**Addendum No. 1
Essex District Court Video Surveillance System
Project No. K22-0047-73**

01/26/2022

The purpose of this addendum is to amend and clarify certain portions of the above-referenced solicitation with all prospective bidders/offerors.

Attachment 1 - Floor Plan Plumbing and Roof Plan

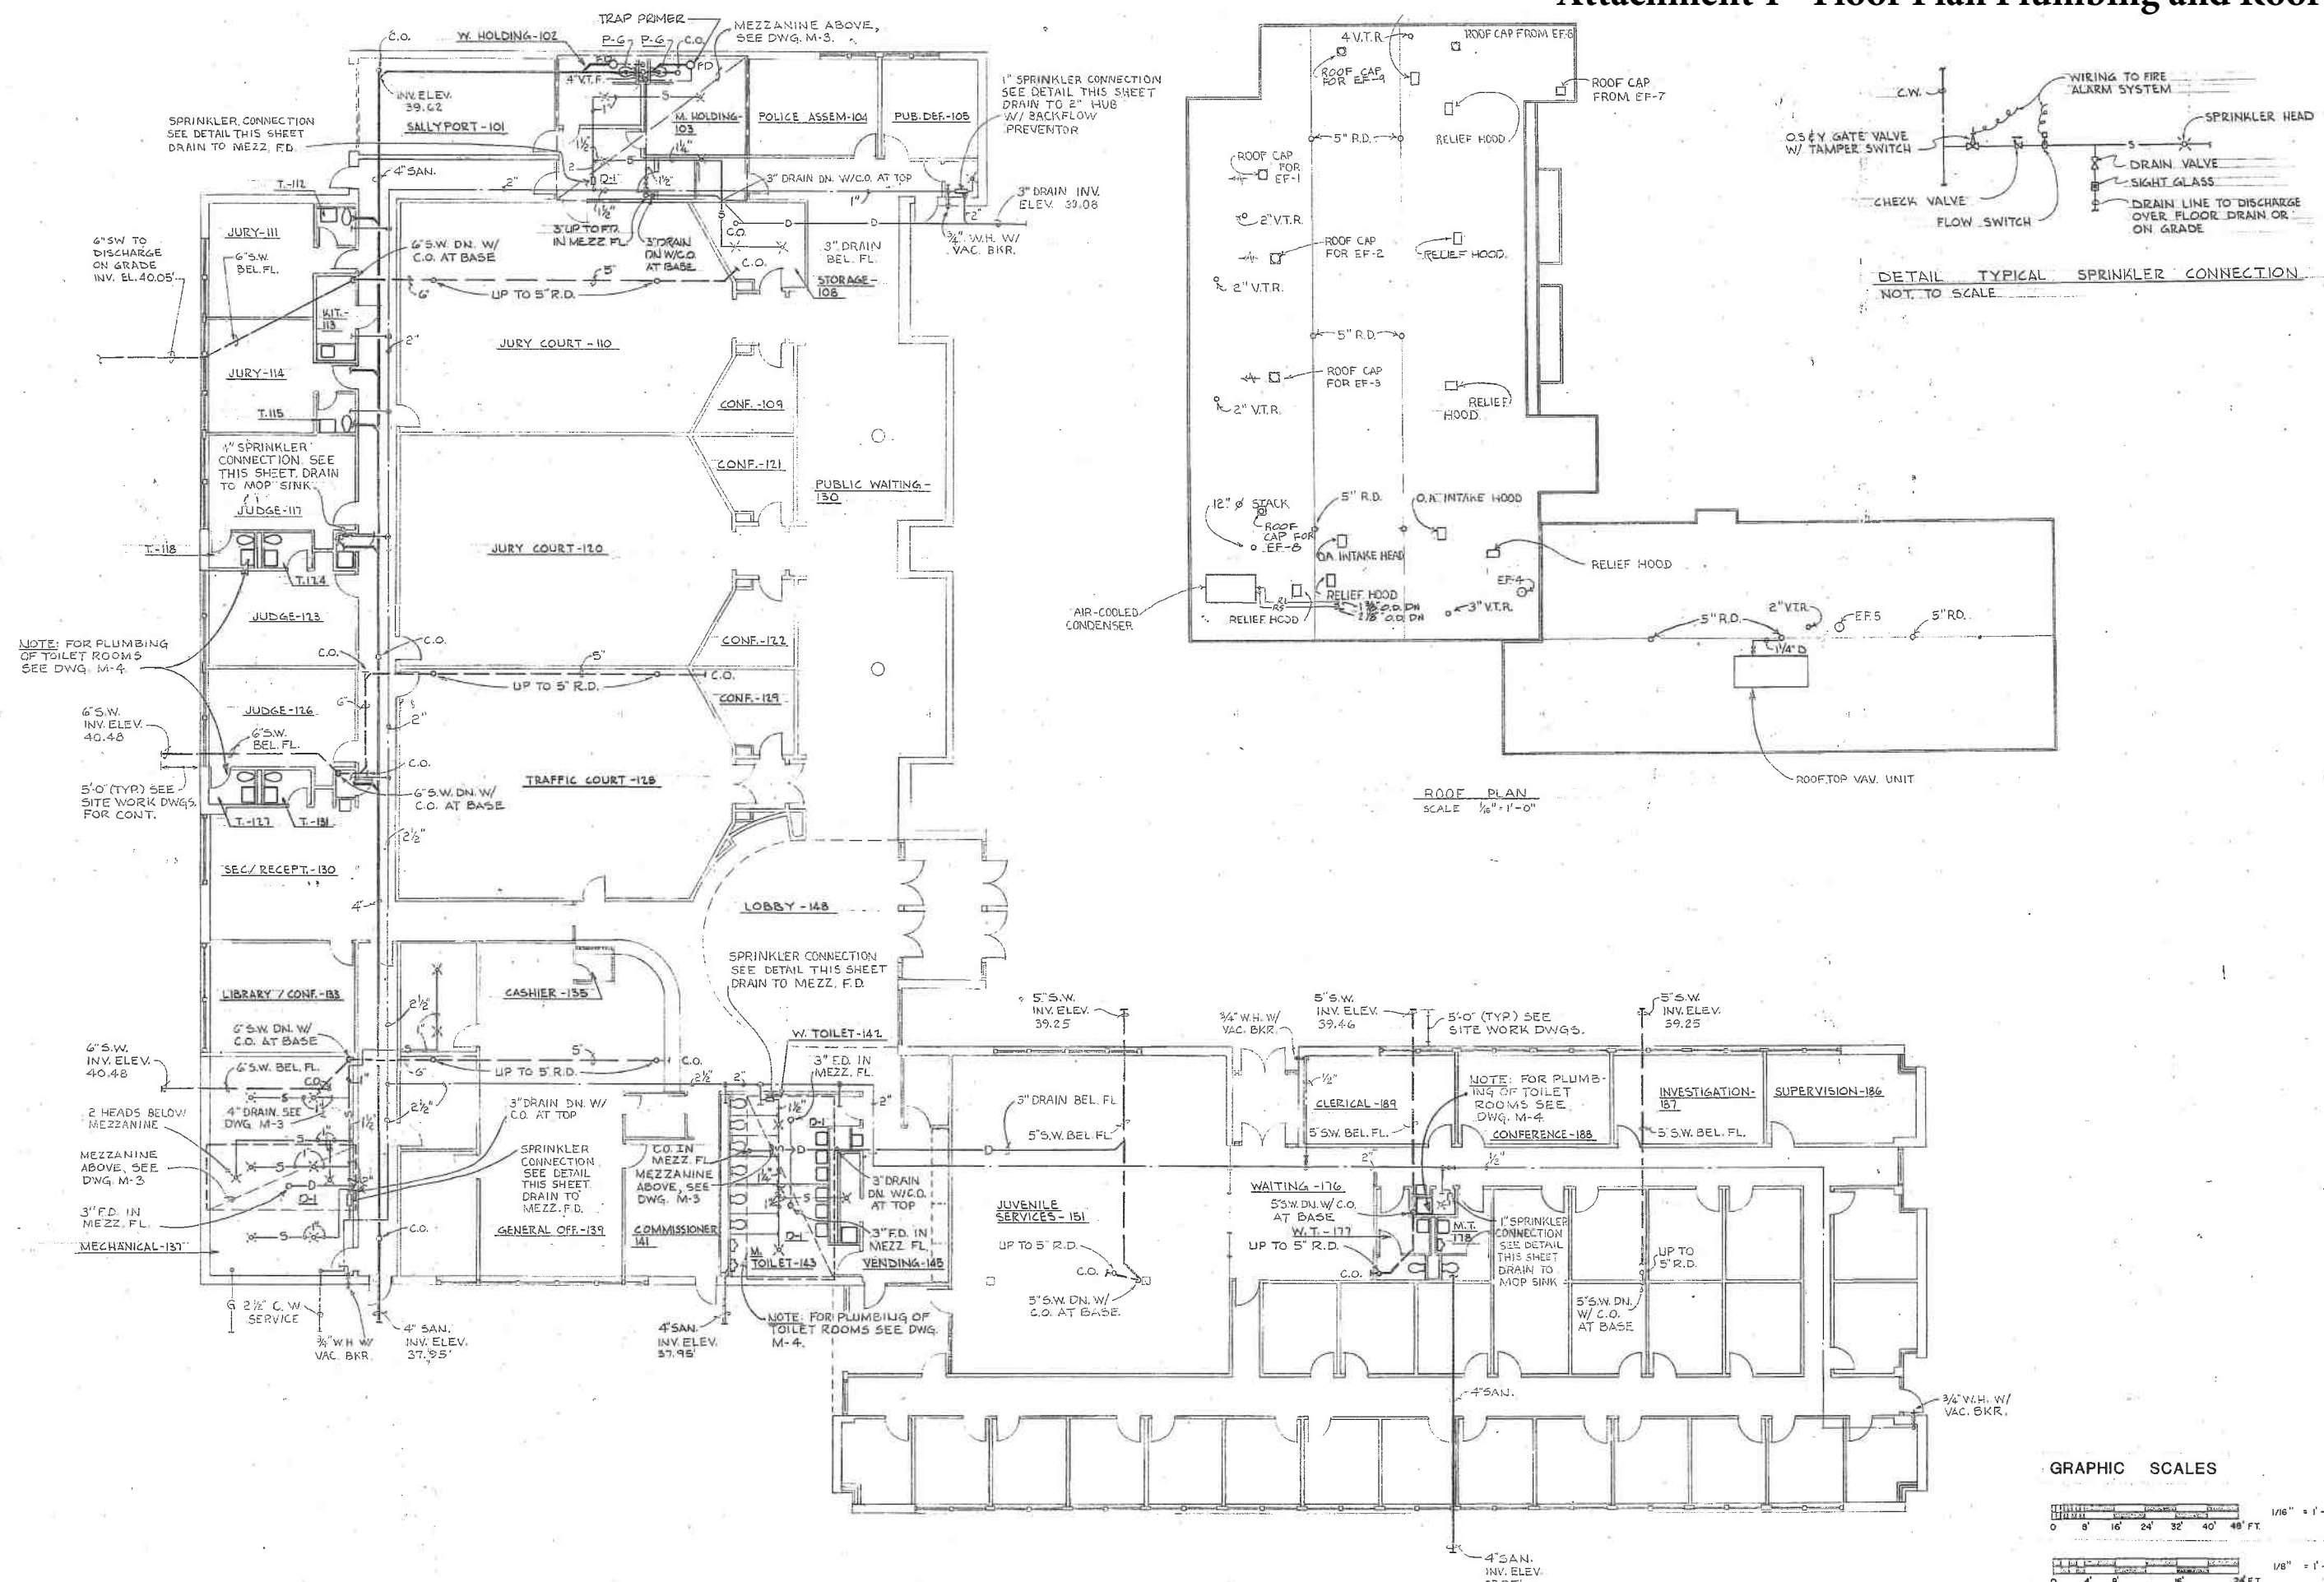
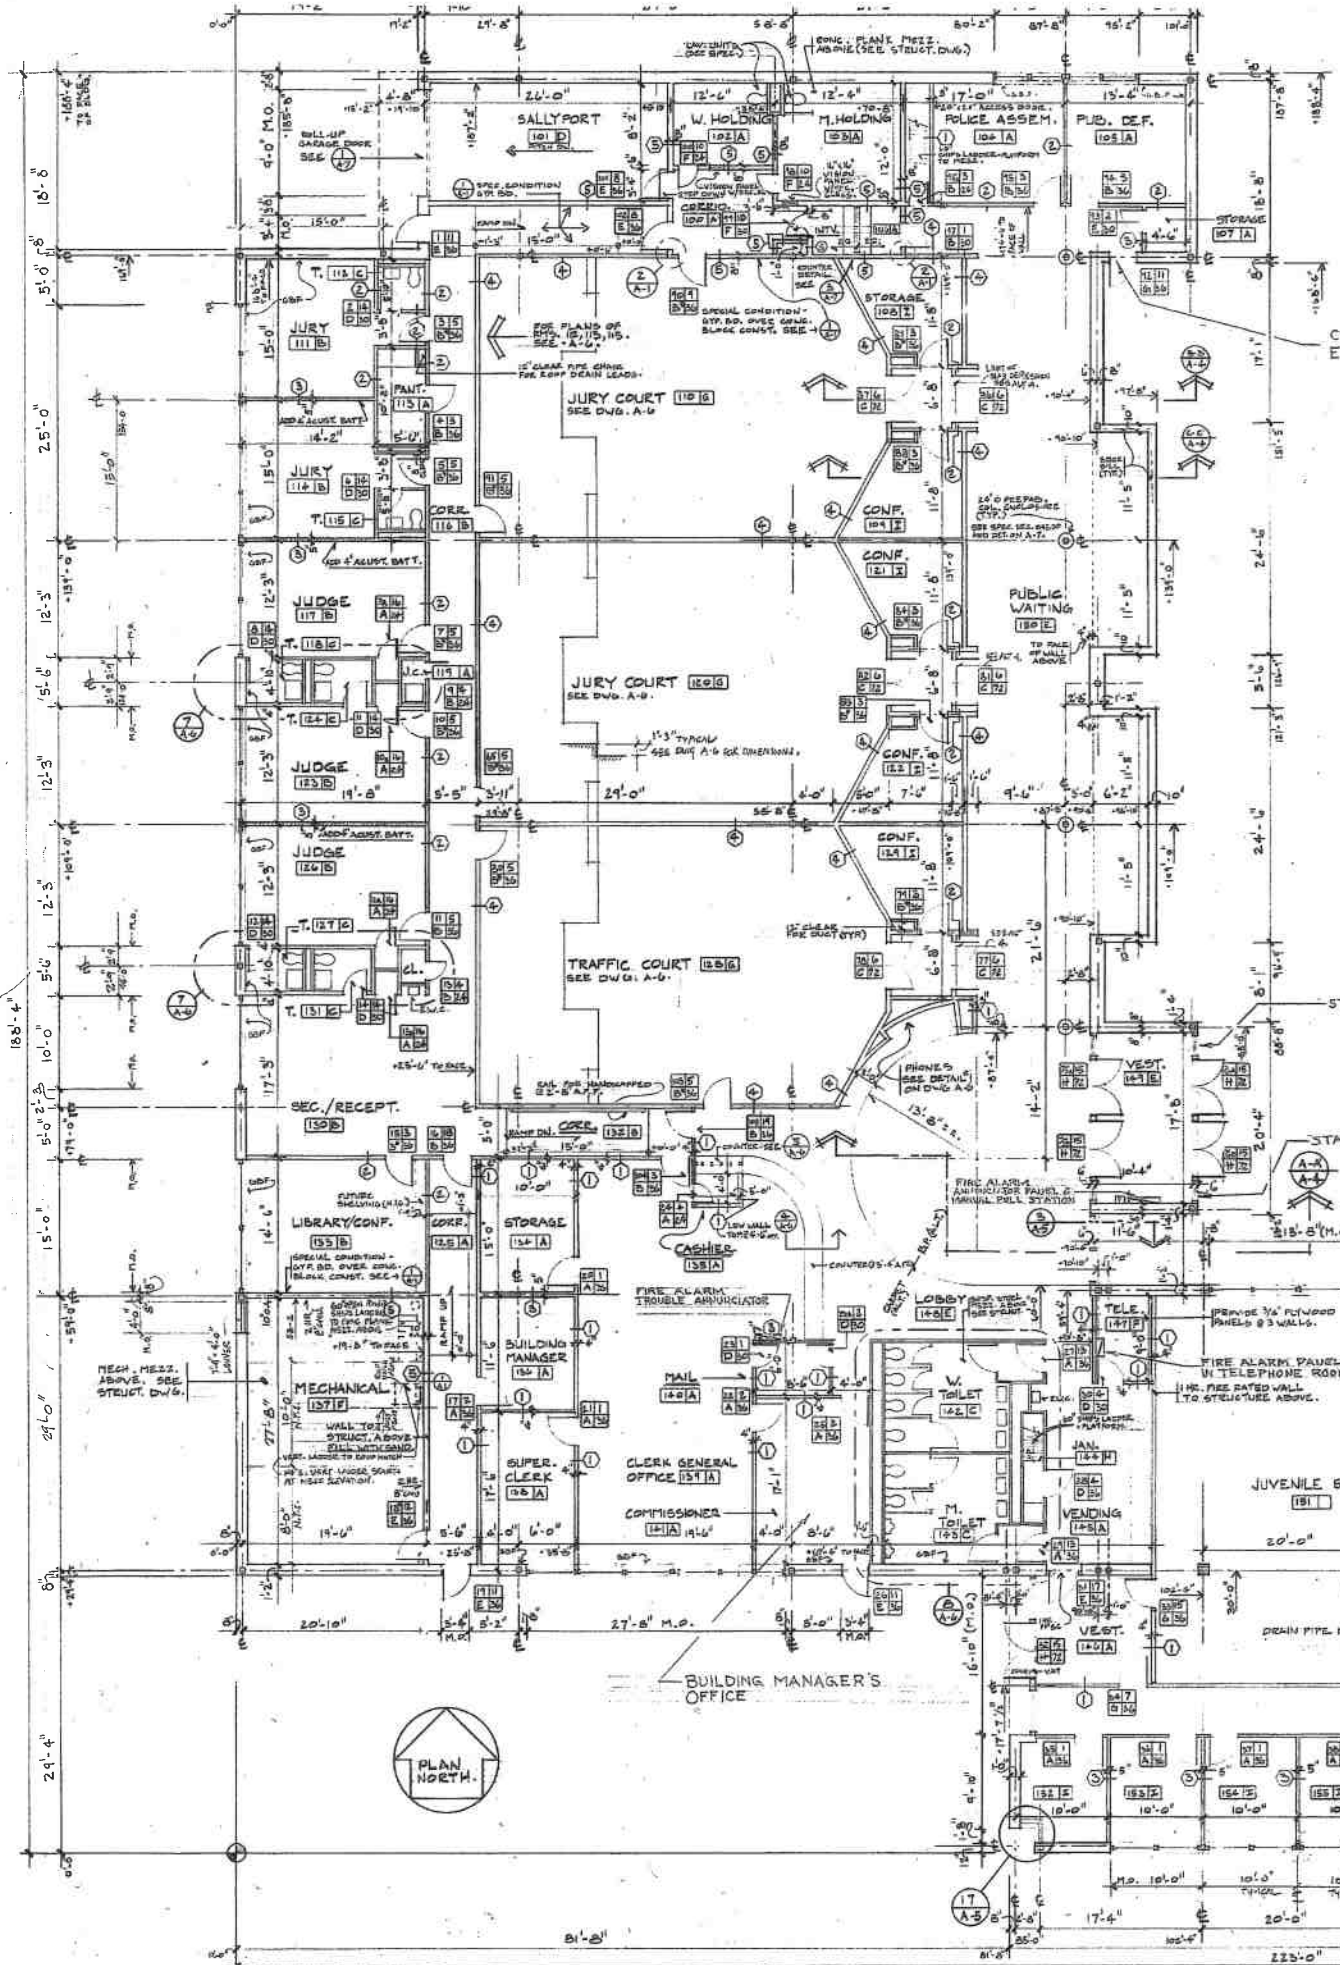
- Q2.** Is there asbestos in the building?
A2. No.
- Q3.** Do you have CAD drawings with clear dimension for the building?
A3. No. Two additional drawings are included as attachments to this addendum for measurement and scale.
